Crown Street, Phase 3 – Manchester

DESIGN & ACCESS STATEMENT - ADDENDUM | APRIL 2024
Z1-SHP-A180-RP-XX-B5D803 | REVISION X03

Unit C7-1

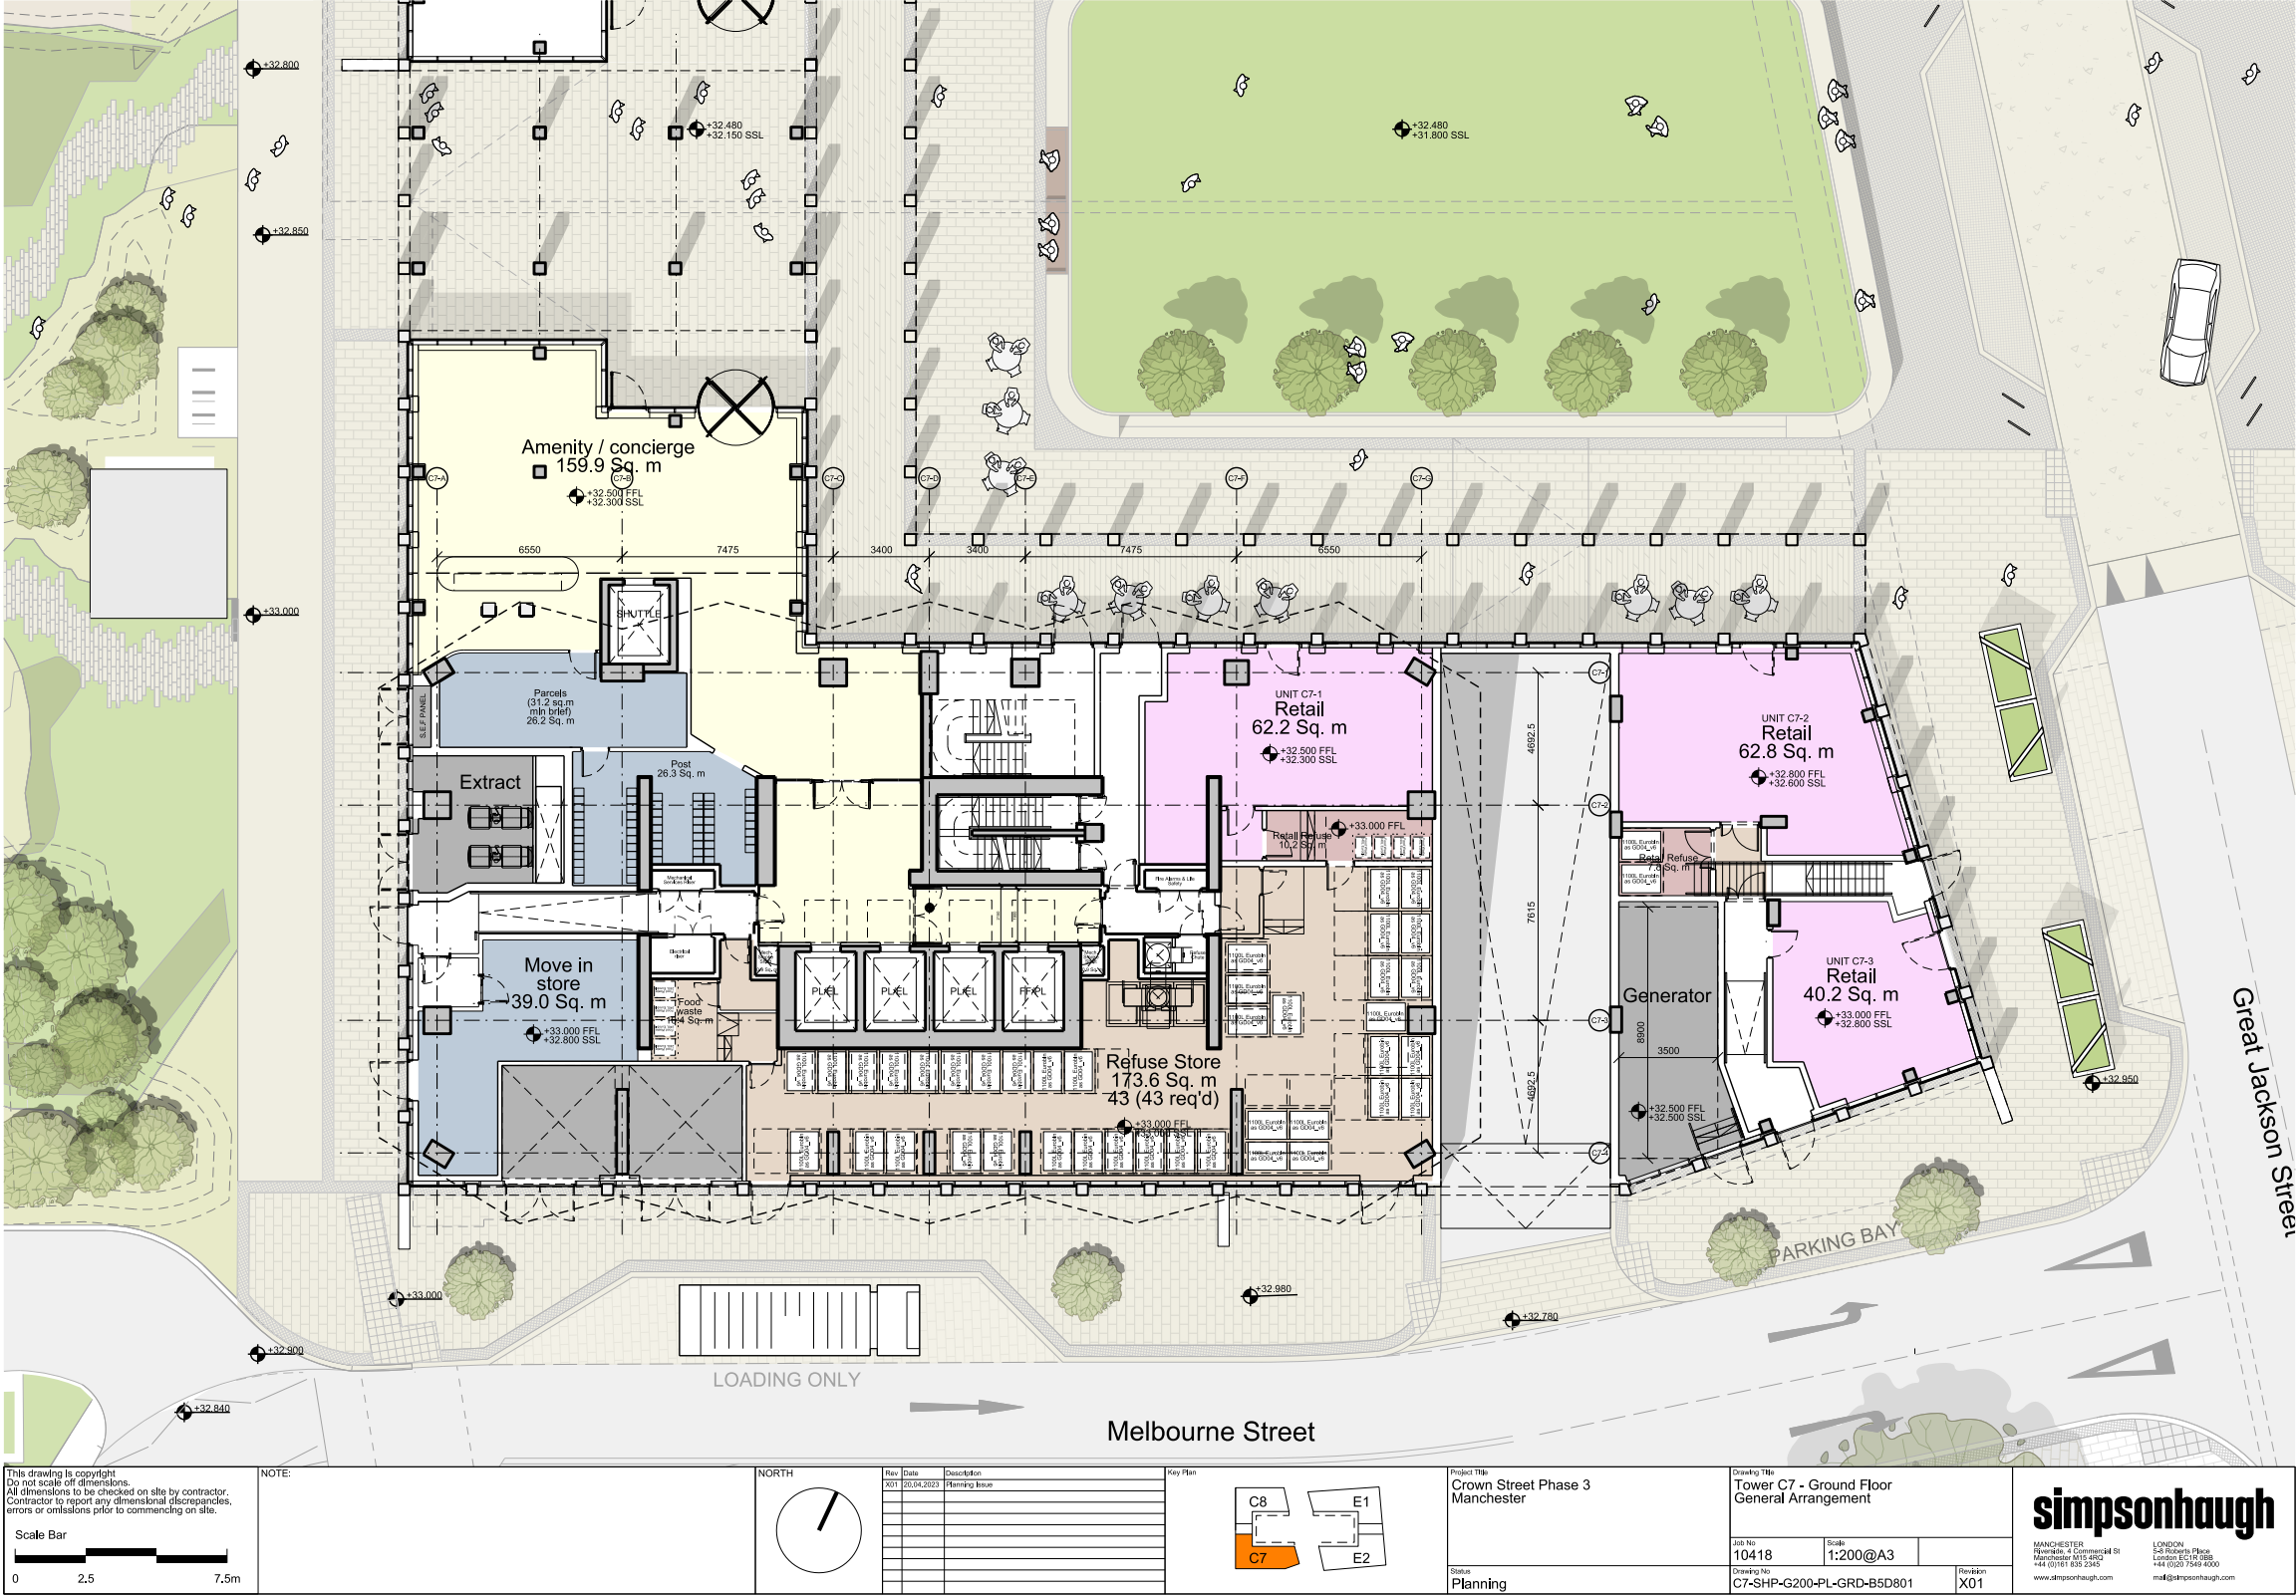
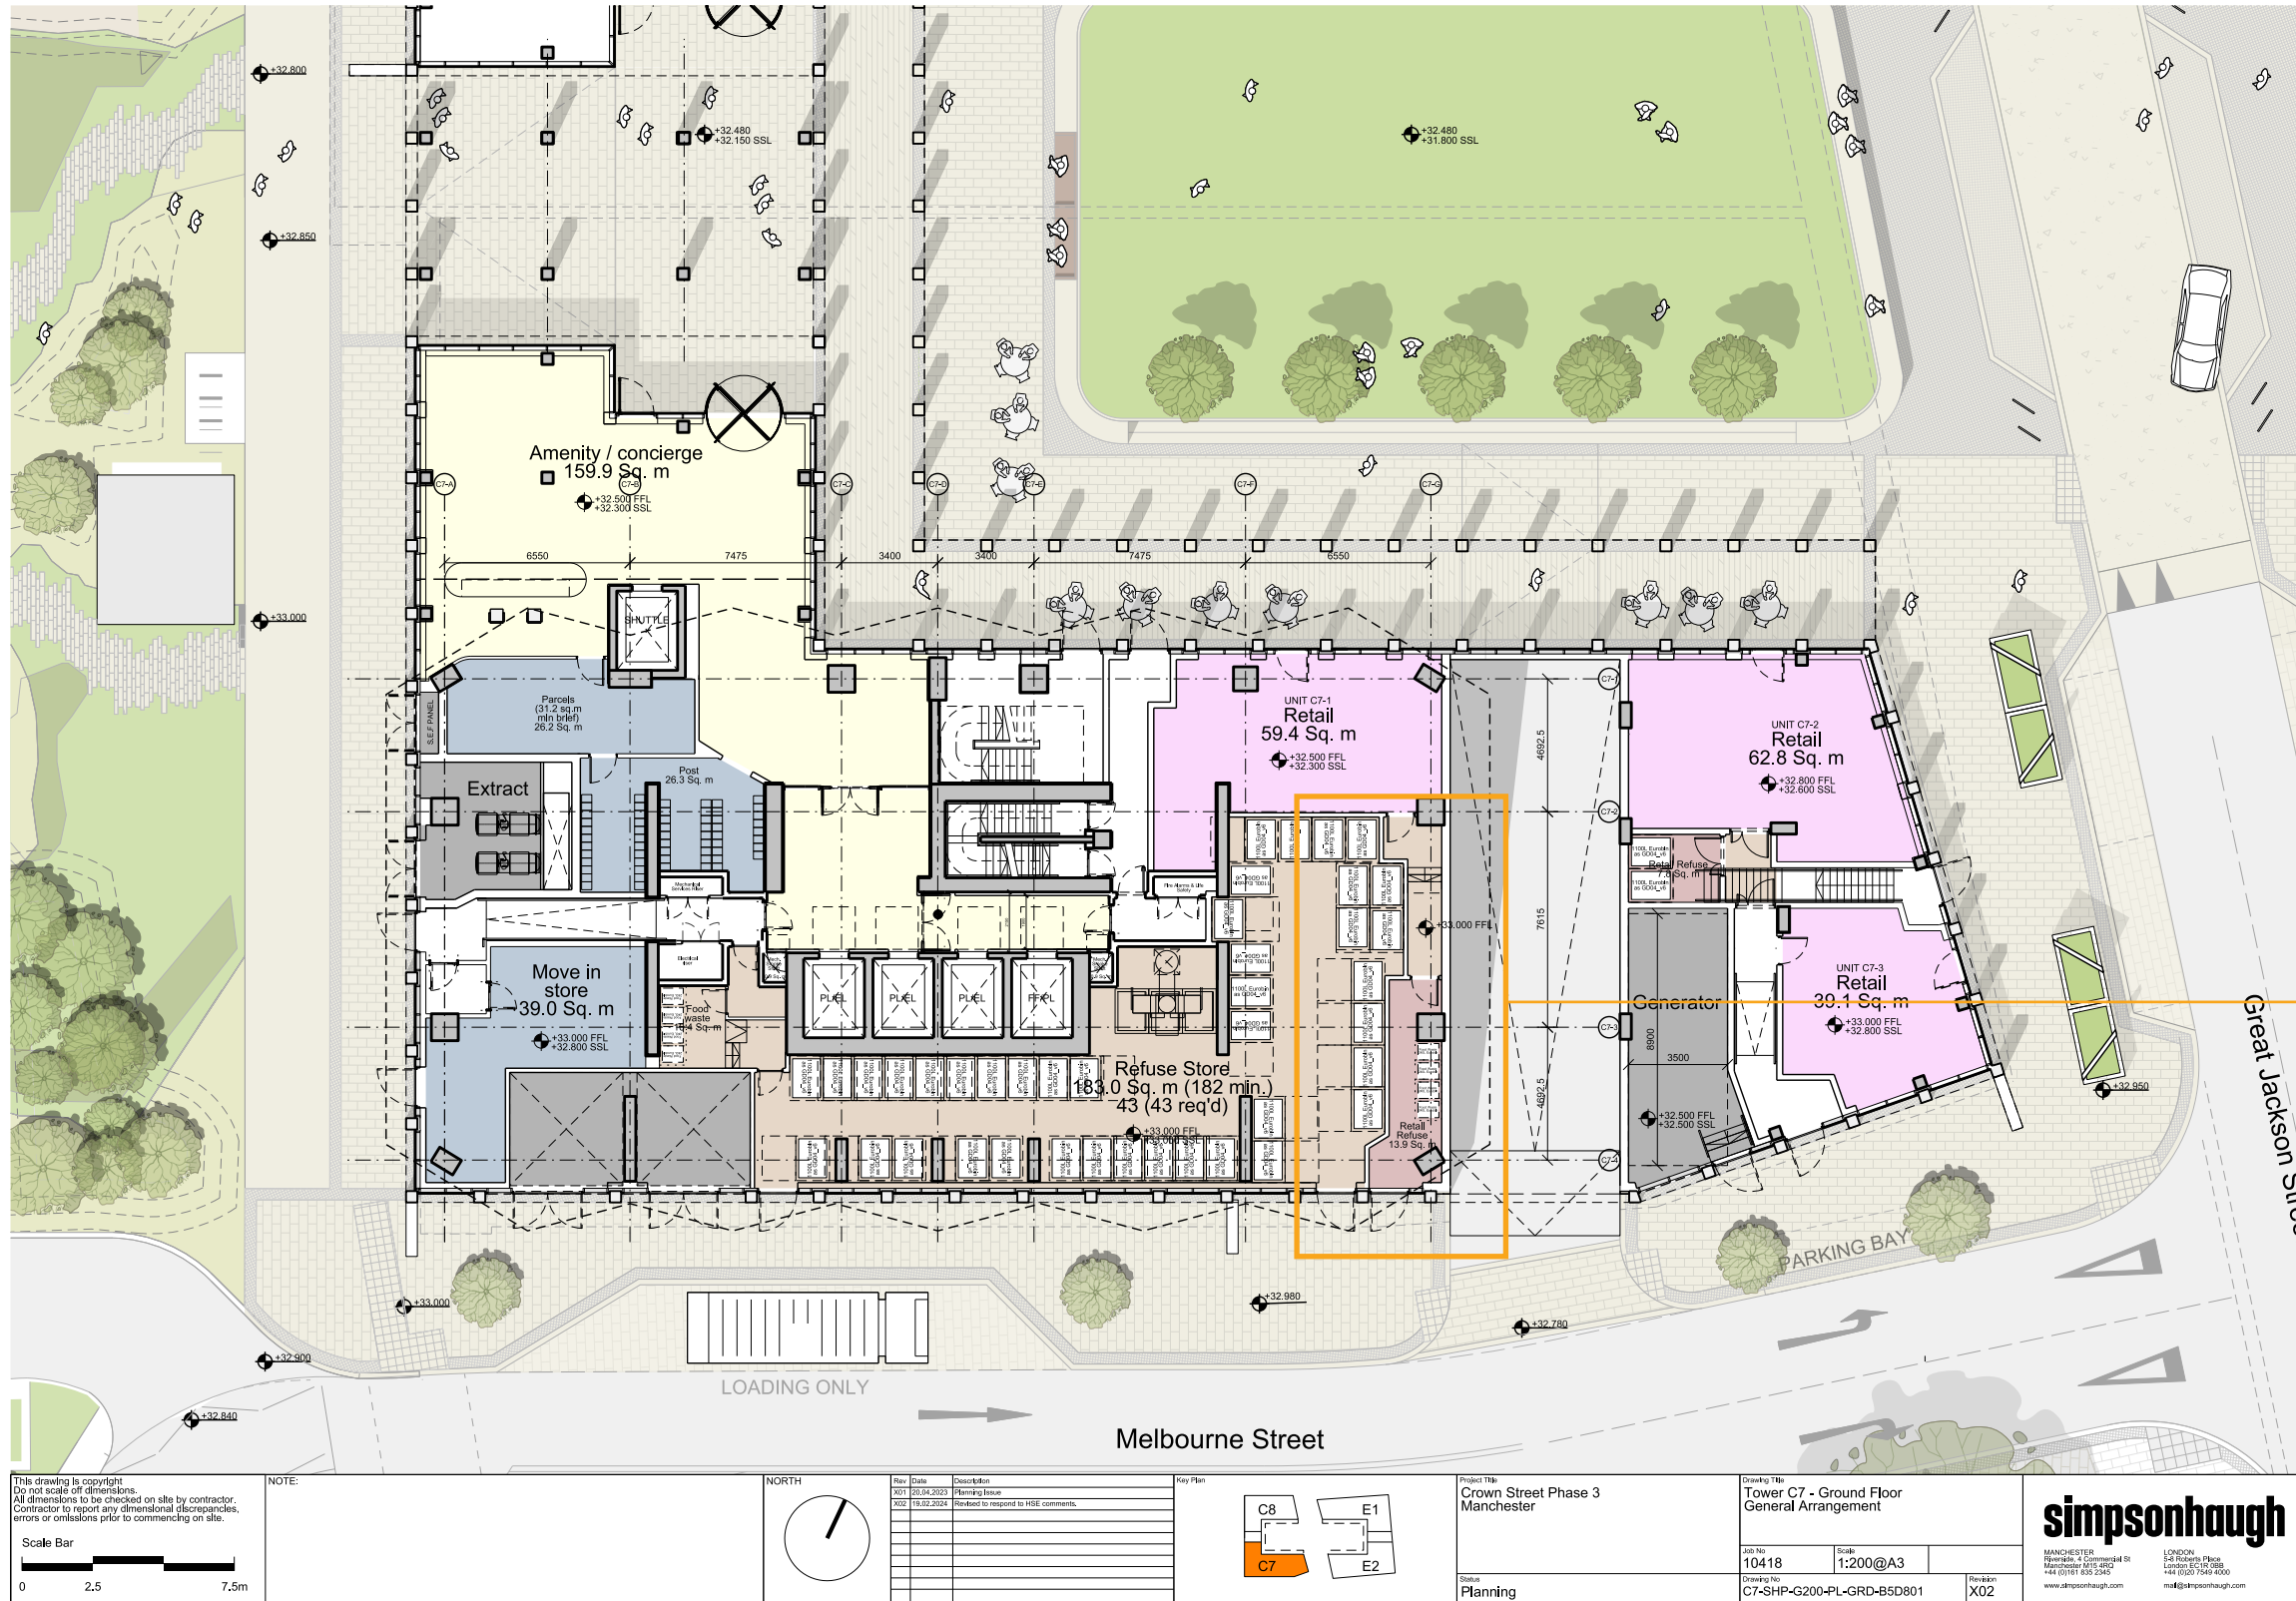
It is noted that commercial units C7-1, E1-1, 2, 3 and 4 and E2-2 link to the residential accommodation by way of the refuse holding stores and lobby to the fire-fighting stairs.

1.6. Whilst it is noted that the stair to the ground floor commercial and the stair to the residential floors are separated by lobbies at ground floor, the adopted fire safety standard states:

“Any stair serving a dwelling within a mixed-use development should not communicate with any other occupancy, unless in accordance with a) or b)...a) In buildings having not more than three storeys above ground or access level (small buildings), common stairs that serve both dwellings and other occupancies should be separated from each occupancy by protected lobbies at all levels. b) In buildings having more than three storeys above ground or access level: 1) all stairs serving dwellings, which are not ancillary to the main use of the building, should not communicate with any other occupancy in that building...”

Accordingly, the lobbied communication of commercial and residential staircases is not appropriate as the development is not a small building. Design changes necessary to provide separated means of escape will affect land use planning considerations such as the layout and appearance of the development.

A fire-separated corridor and independent refuse store has been created for Unit C7-1 to remove the link between the commercial unit and residential accommodation.

A fire-separated corridor and independent refuse store will be created for Unit C7-1 to remove the link between the commercial unit and residential accommodation.

Amendments in response to HSE comments.
